WATER QUALITY MEMORANDUM

Utah Coal Regulatory Program

RE: Fourth Quarter 2016 Water Monitoring, PacifiCorp, Deer Creek Mine.
C/015/0018, Task ID #5380

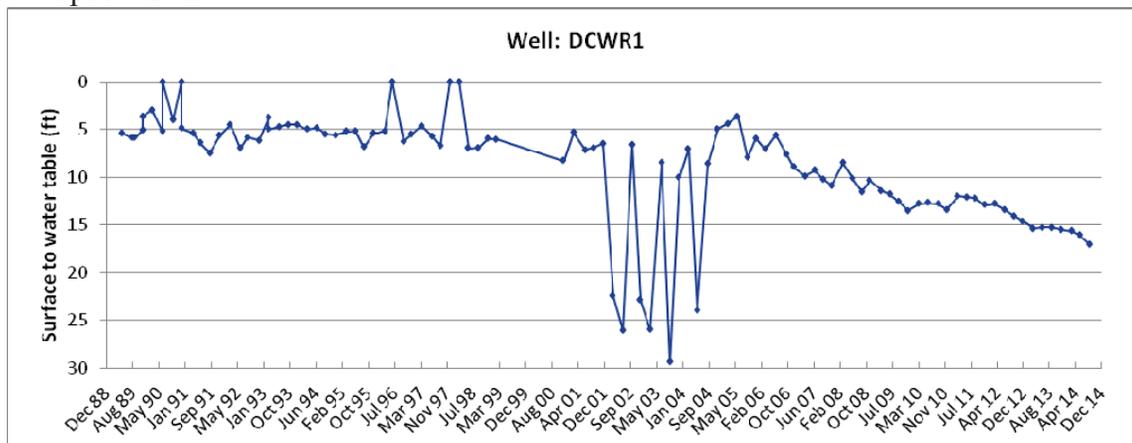
The Deer Creek Waste Rock well has been dropping since 2006 (following a small rise in 2004-2005). These changes are probably from factors other than disposal of waste rock at this site: a similar drop in water level is seen at WCWR1 at the Cottonwood/Wilberg Mine Waste Rock Disposal Site.

This well is no longer a Pacificorp water monitored site. It is now monitored by BRC as the

Deer Creek Waste Rock site.
